Re: Saddle Creek Drain Section 9 Arm

Re: Saddle Creek Drain: Sec. 9 Arm

CONSTRUCTION PLANS FOR SADDLECREEK SECTION 7-9

Map Correction-Field Verification

C703

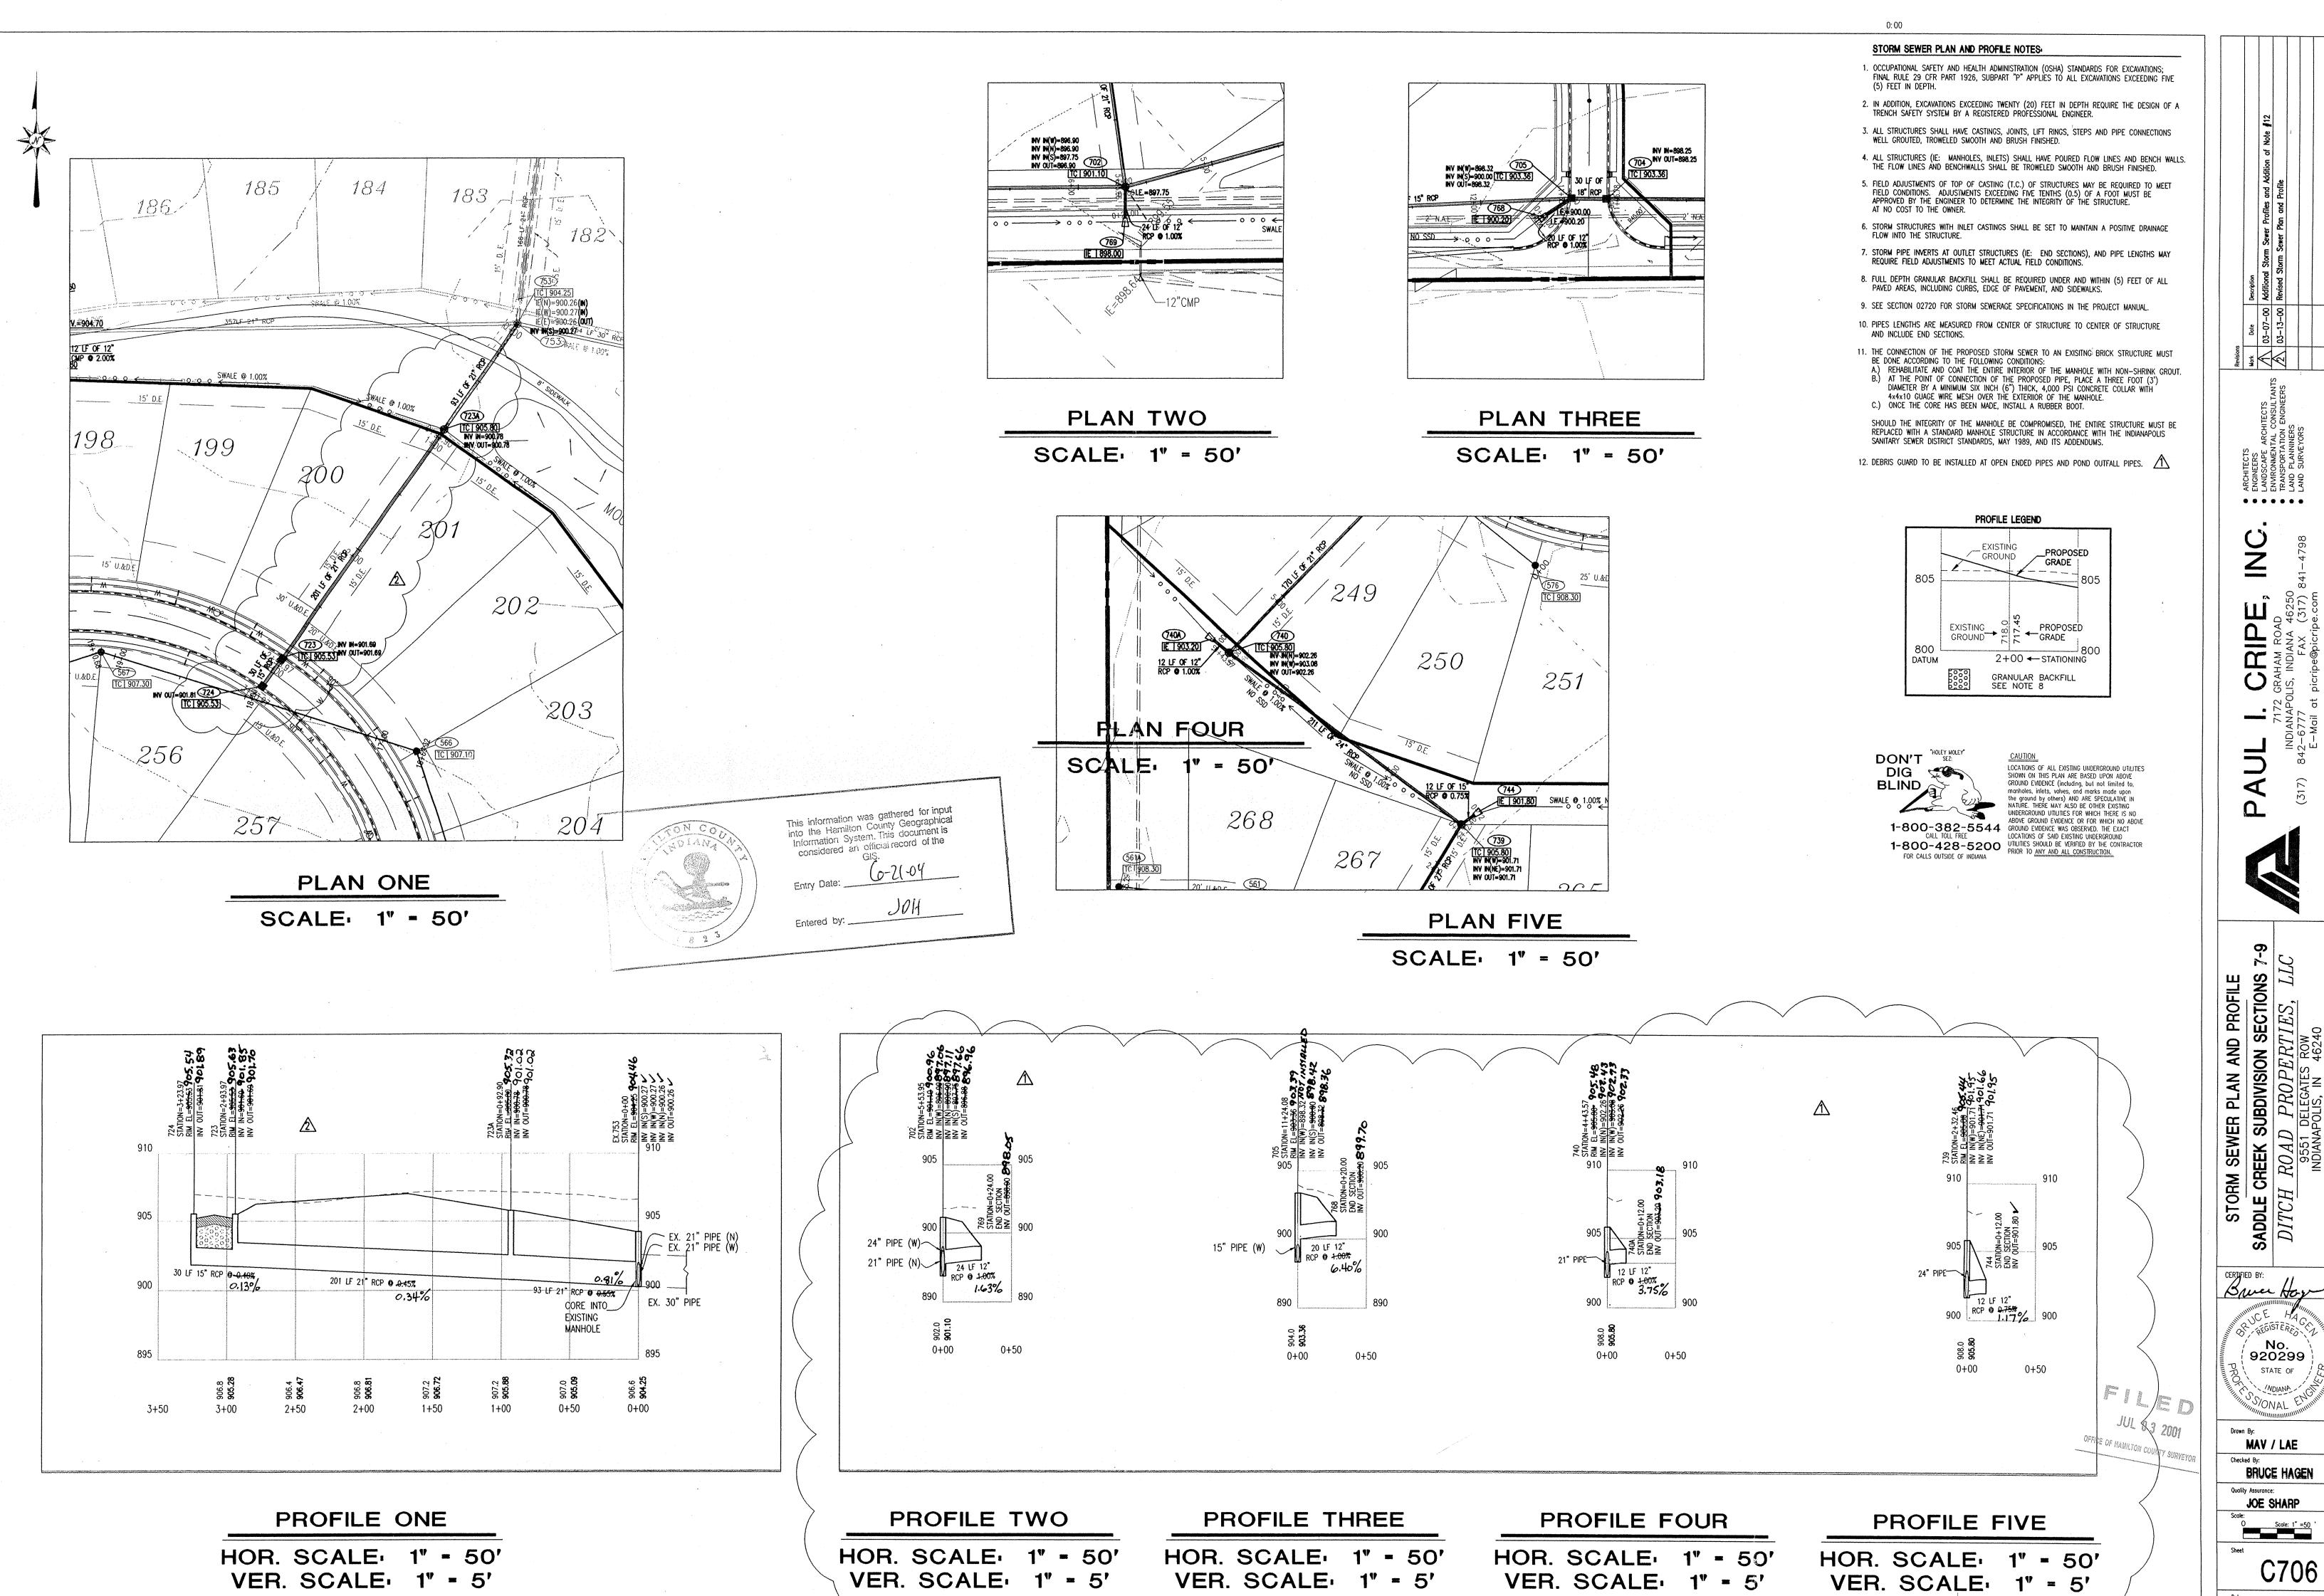
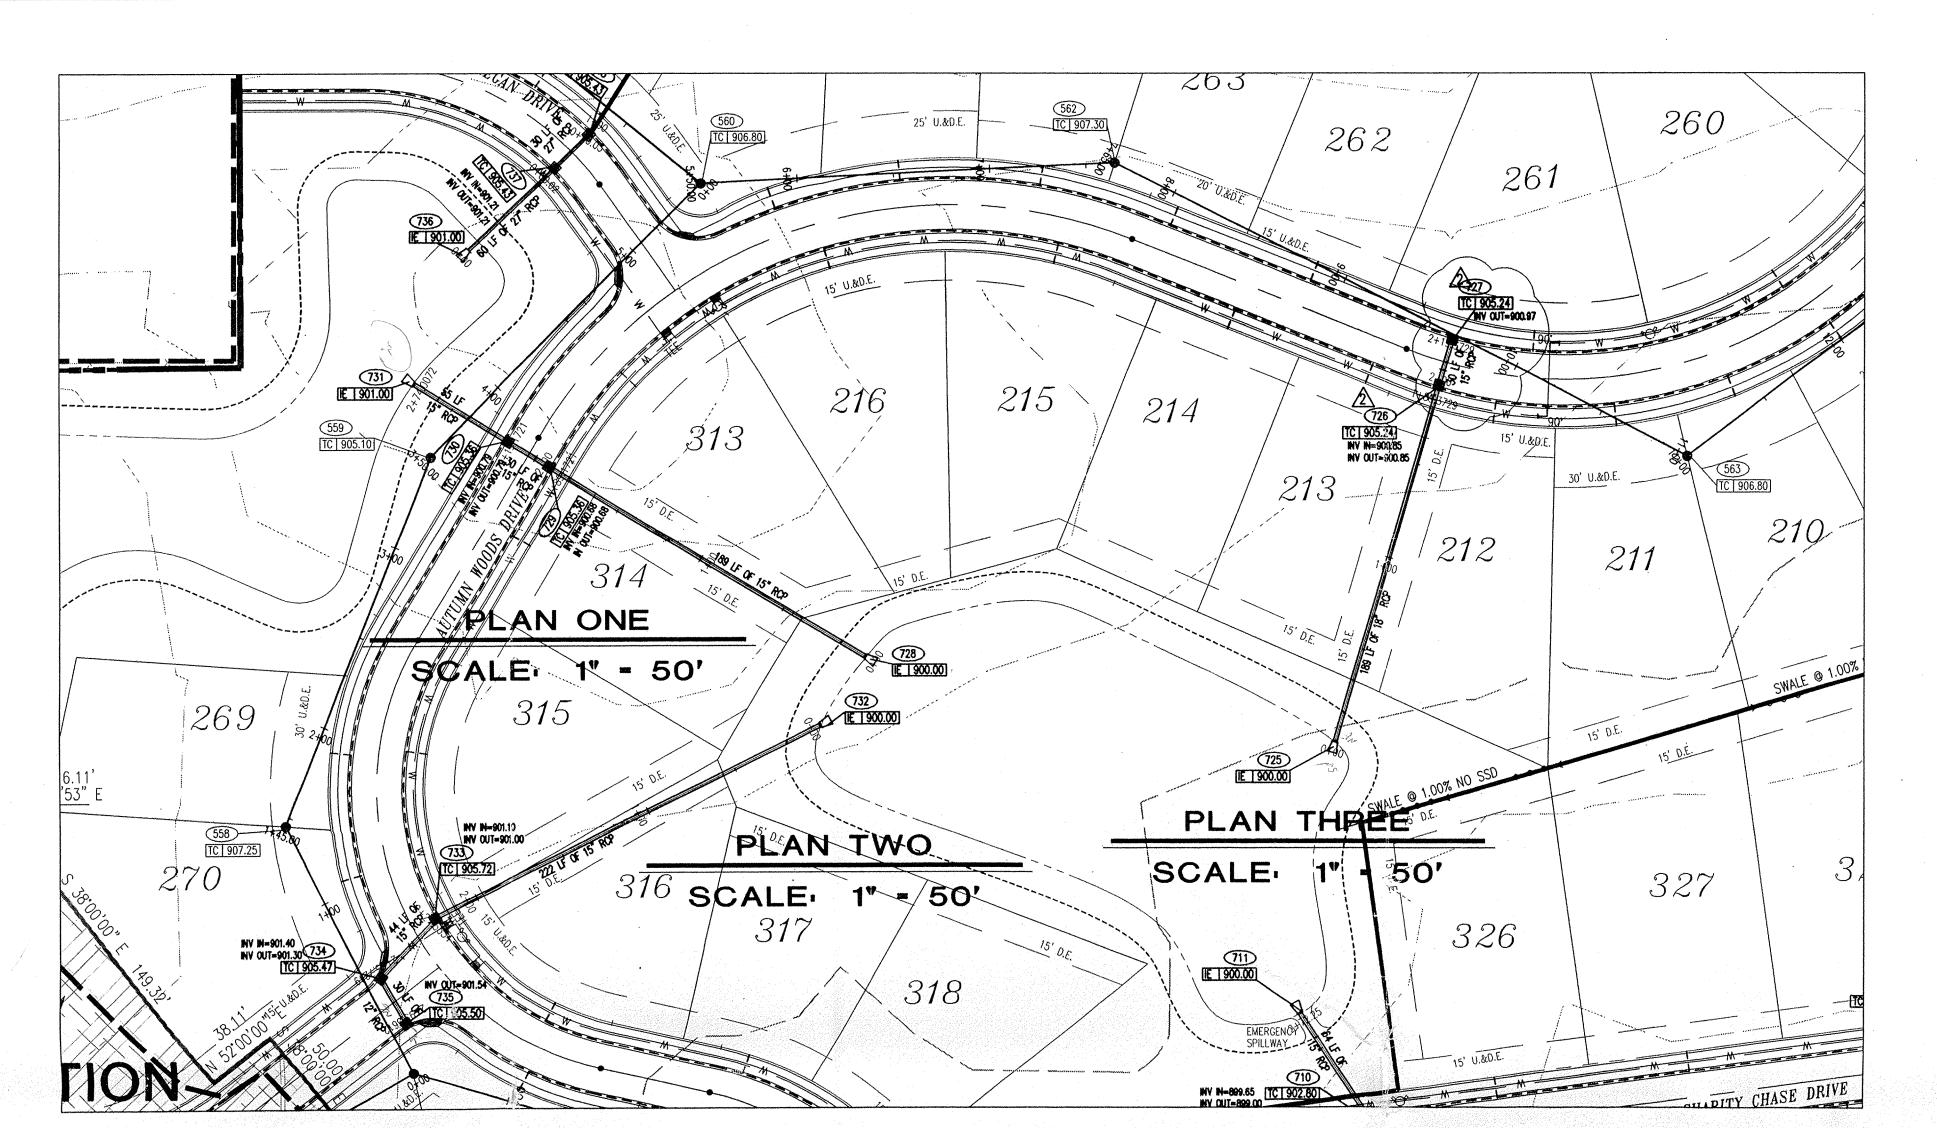
Structures 746-747 was included in the footage for the final report but was never built. Therefore, this 89 feet of 18" RCP should be removed from the drains length.

Change +/-:-89

New Length: 5774
